B14000395

Building Address: 5107 HOLLY CREEK LANE
CLARKSVILLE MD 21029
 Suite/Apt. # N/A SDP/WP/BA #:
 Census Tract: Subdivision: WALNUT GROVE
 Section: Area: Lot: 65
 Tax Map: 0028 Parcel: 0074 Grid: 0018
 Zoning: Map Coordinates: Lot Size: 36976.50

Existing Use: VACANT LOT
 Proposed Use: SINGLE FAMILY DWELLING
 Estimated Construction Cost: \$ 570,000
 Description of Work: CONSTRUCT CUSTOM SFD

From: Bricker, Robert
Sent: Tuesday, April 01, 2014 1:31 PM
To: 'Adam Hall'
Cc: Donald Taylor; Steve Appler; Williams, Jeffrey
Subject: RE: floor plan issues-RE: B14000395

APP. SAN _____ DATE: 4/6/15

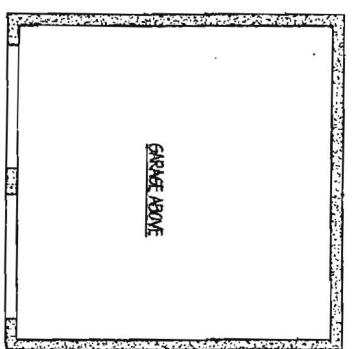
DESC. OF WORK: Basement plus approved. No BR addition.
 SED already meet 5 BR.
 To Finish basement only!
